**UNITED STATES ENVIRONMENTAL PROTECTION AGENCY
REGION 2**

SUBJECT: Responses to National Remedy Review Board and Contaminated Sediments Technical Advisory Group Recommendations for the Lower Eight Miles of the Lower Passaic River, part of the Diamond Alkali Superfund Site in Newark, New Jersey

Figure 2
2013

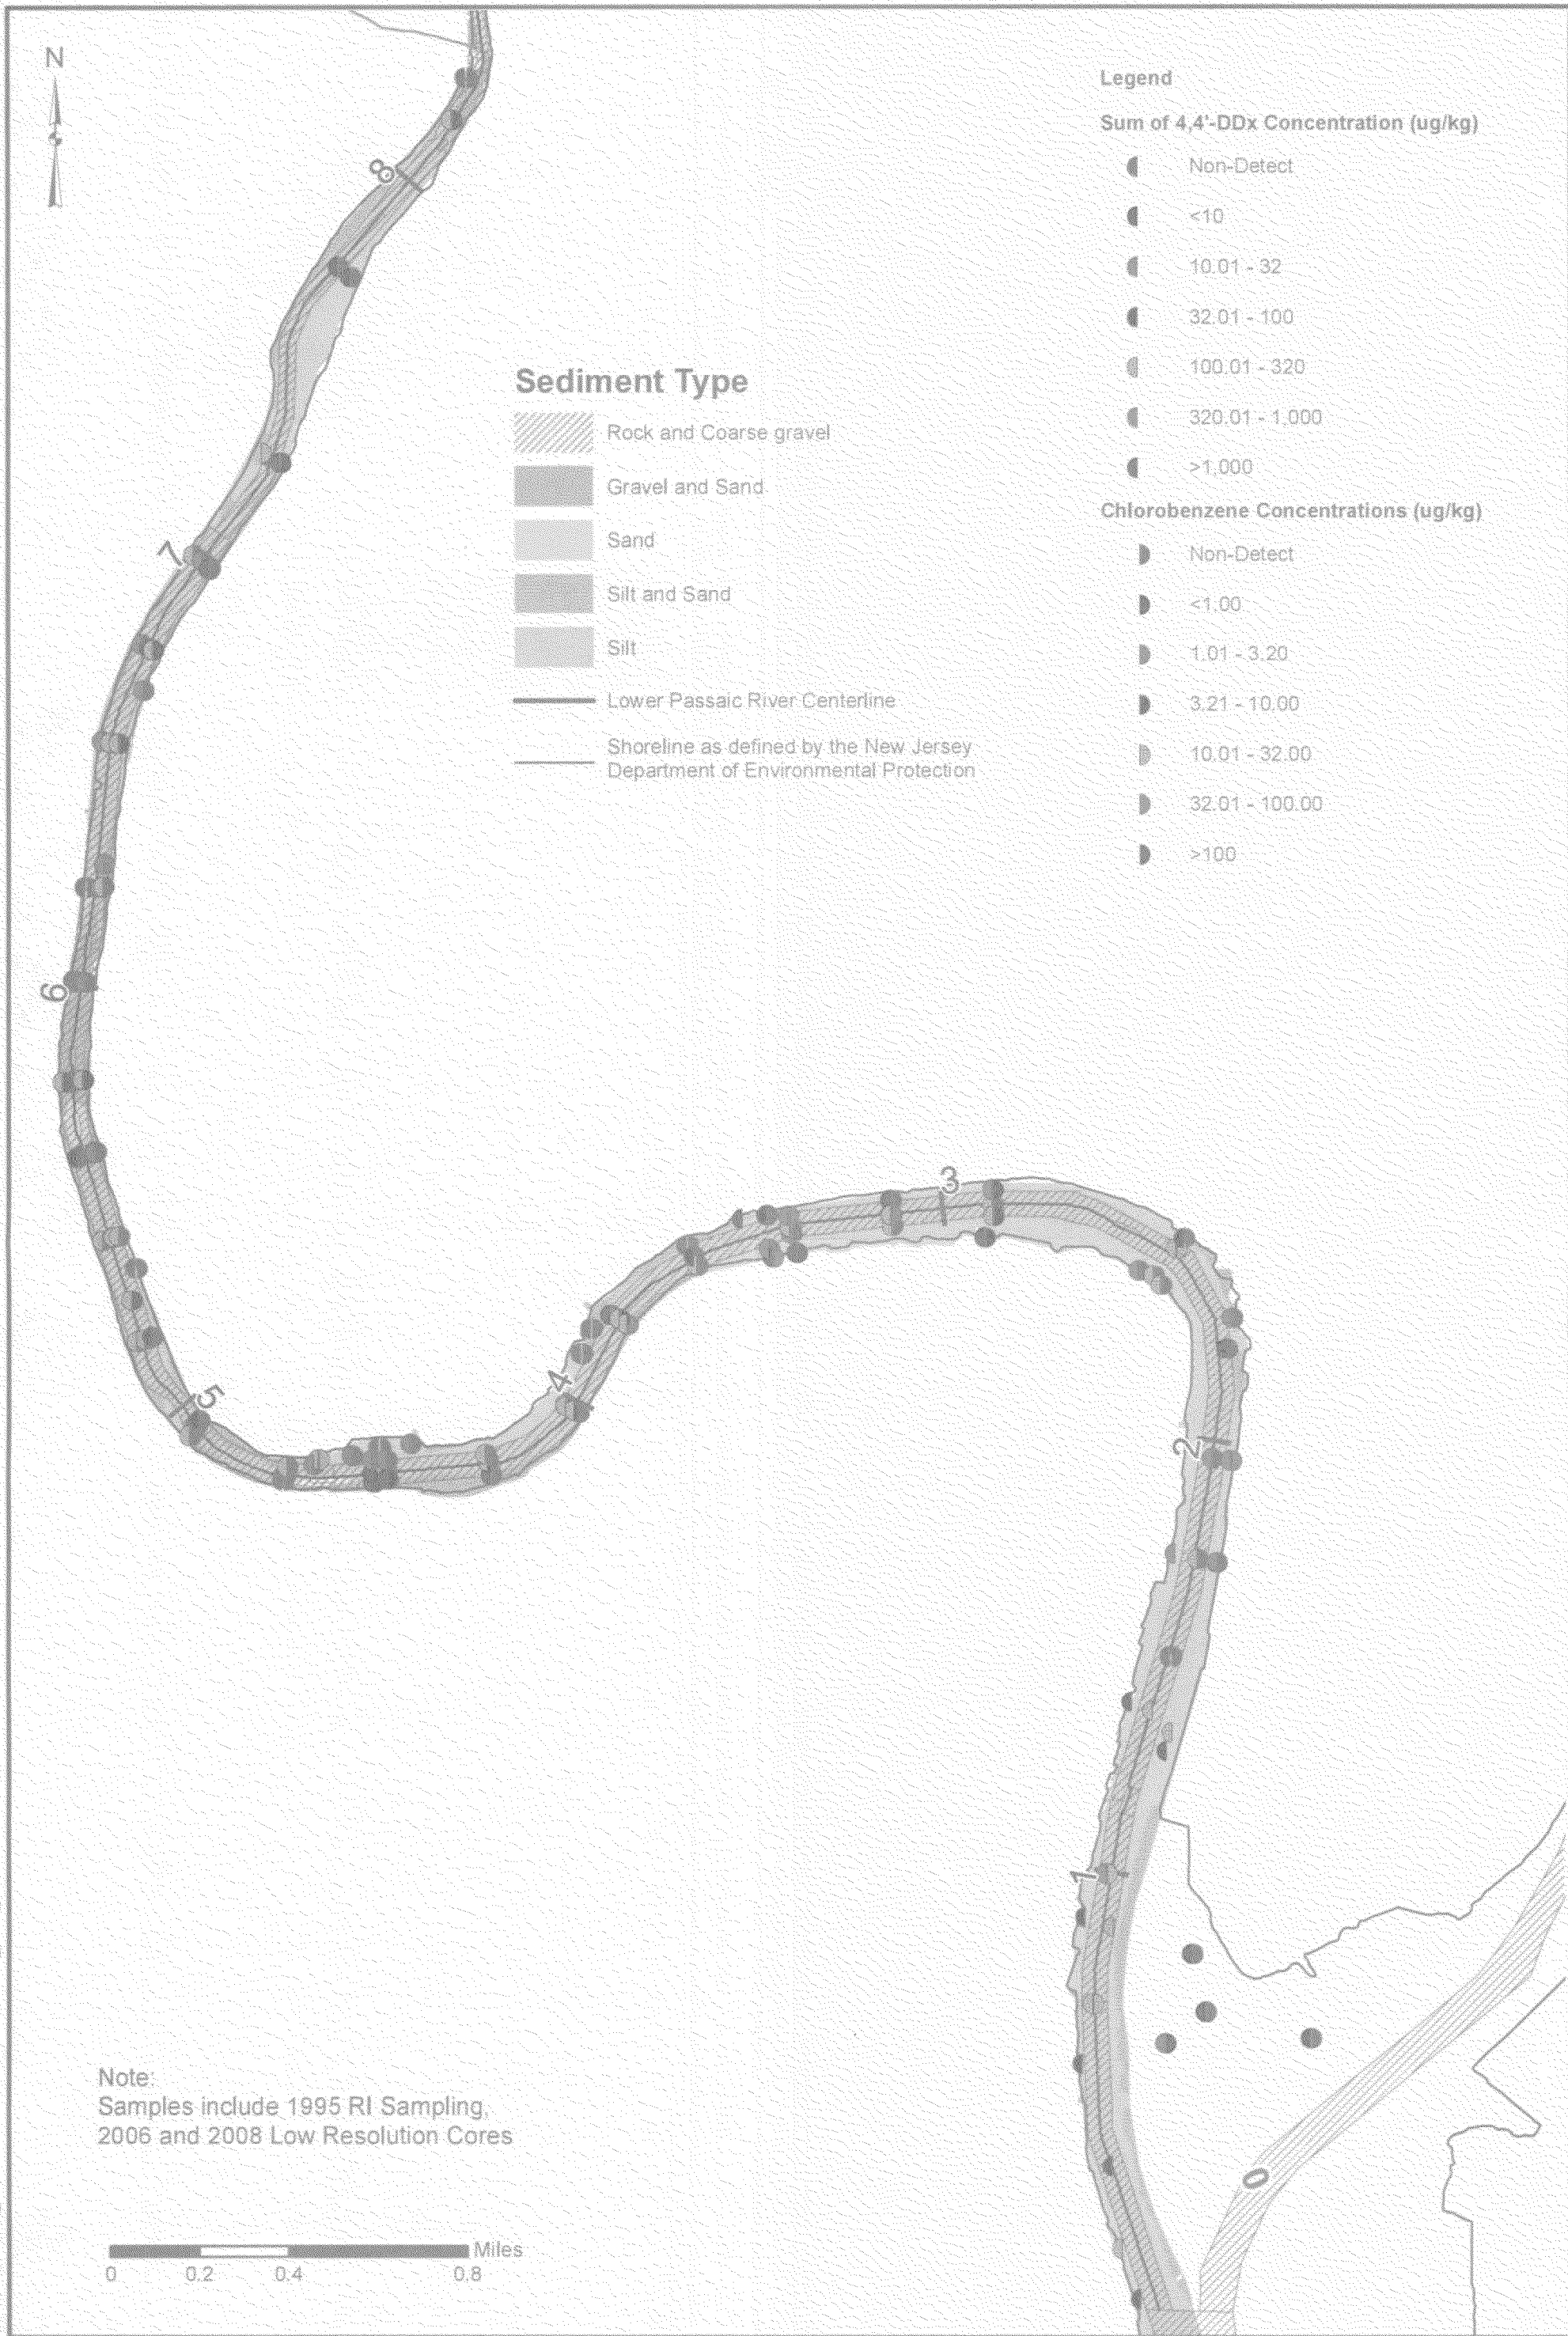
Recommendation: Based on the information provided by the Region, the Boards note that the pesticide DDT and its degradation products (DDx) are contaminants of concern (COCs) in the river sediments. The documents provided to the Boards did not provide clear information on the transport pathways of DDx. The transport pathways may have included historic direct wastewater discharge to the Passaic River, and may now include contaminated surface water runoff and groundwater upwelling to the river sediments. Information obtained by EPA at other DDT manufacturing sites indicates that chlorobenzene is typically used as a solvent and carrier for DDT at a 1:1 mass ratio during the manufacturing process. The Boards recommend that the Region confirm whether chlorobenzene is or may be a DDx co-contaminant in the soil and groundwater. In addition, the Boards recommend that additional soil and groundwater characterization be conducted to evaluate the DDx contributions and, if present, chlorobenzene as the sources to the overall DDx and chlorobenzene loads in the river sediments. If the Region identifies chlorobenzene at actionable levels, the Boards further recommend that the Region address it in its decision documents as part of the remedy selection process (either in the current Record of Decision [ROD] or in a future decision document). The Boards recommend that the Region consider as a potential alternative an enhanced (active layer component) sand cap for river stretches where mobile COCs such as chlorobenzene are associated with high groundwater discharge rates or non-aqueous phase liquid (NAPL) seepage into the river sediment.

Response: Chlorobenzene and Total DDx concentrations from sediment cores collected in 1995, 2006 and 2008 are plotted in Figures 1 and 2 (attached). Figure 1 shows surface sediment concentrations and Figure 2 shows concentrations that would be exposed after dredging in Alternative 3. In Figure 1, surface sediment concentrations of chlorobenzene are almost all non-detect, and the few detected values do not exceed 10 ppb. In Figure 2, for the surface that would be exposed after dredging in Alternative 3, most concentrations of chlorobenzene are still non-detect. Of the few detected values, all were below 50 ppb, except for one at 2,200 ppb, located in the Phase 1 Removal area, which, in 2012, was dredged down to 12 feet and backfilled, so the sediment containing that elevated chlorobenzene is no longer present. To put these values into context, threshold values for chlorobenzene intended to be conservative predictors of health effects were developed at the beginning stages of the FFS risk assessments, when the Region was screening data to determine contaminants of potential concern (COPCs) and contaminants of potential ecological concern (COPECs). The most conservative screening value for chlorobenzene was an ecological risk threshold of 410 ppb, based on Jones et al, 1997. Comparing the sediment concentration data shown in Figures 1 and 2 to the conservative threshold indicates that no chlorobenzene was detected above that threshold in the FFS Study Area. However, if, during remedial design sampling, high concentrations of chlorobenzene are found, the Region would consider an enhanced sand cap for those river stretches. Consideration of enhanced sand caps during remedial design is already included in the FFS and Proposed Plan.
